Our Ref: WBL 17/30 Pt 2

<u>Development Application No. 10.2017.661.1 – Subdivision at West Byron</u> (West Byron Landowners Group)

We refer to Byron Shire Council's requests for further information dated 20 April 2018, 14 May 2018, 19 June 2018 and 3 July 2018 and respond as follows, on behalf of the applicants:

11/02/2018 ACOUSTIC BARRIER_SECTION_ RETURN AT DISTRIBUTOR ROAD (SPINE ROAD: (ROAD 5))

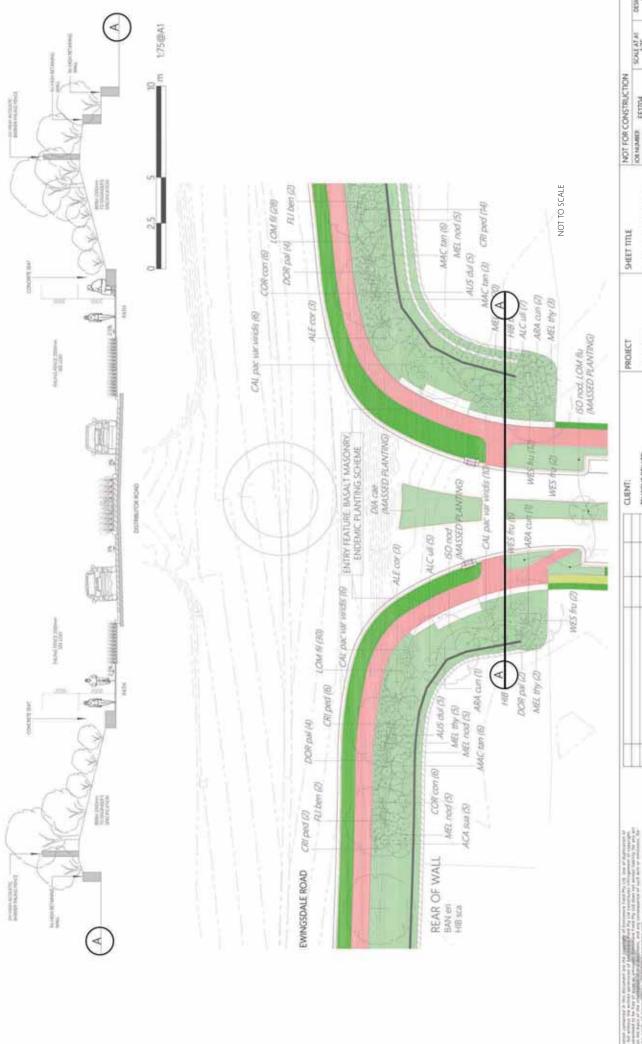
"applicant is to provide a section showing the acoustic barrier returns within the spine road (road no. 5)"

A further section has been provided in addition to LASO1 and is attached to this response BEING LASO8 and LASO8_B. Also attached 3 perspectives SKO1 SKO2 SKO3 to illustrate how the returns are integrated with the landscape treatments and paths.

Image 1 Potential and Preliminary Mitigation Options

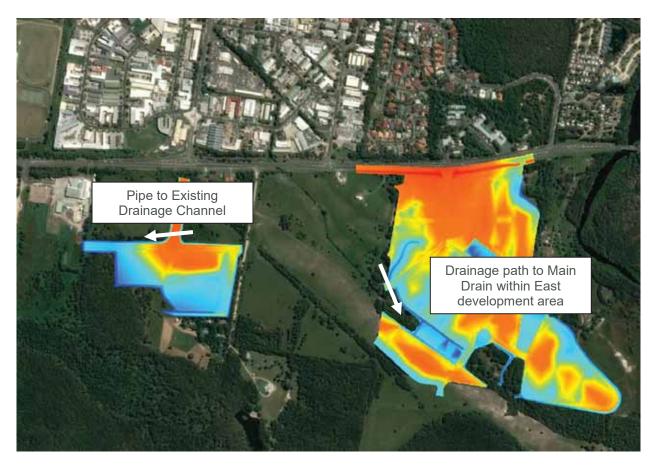
From Figure 1 and Figure 2, the results for both Ewingsdale Road scenarios illustrate that the site in isolation has produced some impacts (peak flood level increases) north of the west development area and from the main drain traversing through Harvest Estate (between the west and east development areas). The details of impacts are as follows:

The mitigation options proposed to remove the impacts are illustrated in Image 1 and are as follows:

- West development area a pipe will be place under the Bayshore Drive extension to allow the water to flow west /southwest to towards BBP in the existing drain towards the Belongil Creek floodplain; and
- East development area a pipe under road to connect the runoff from Villaworld to the main drain.
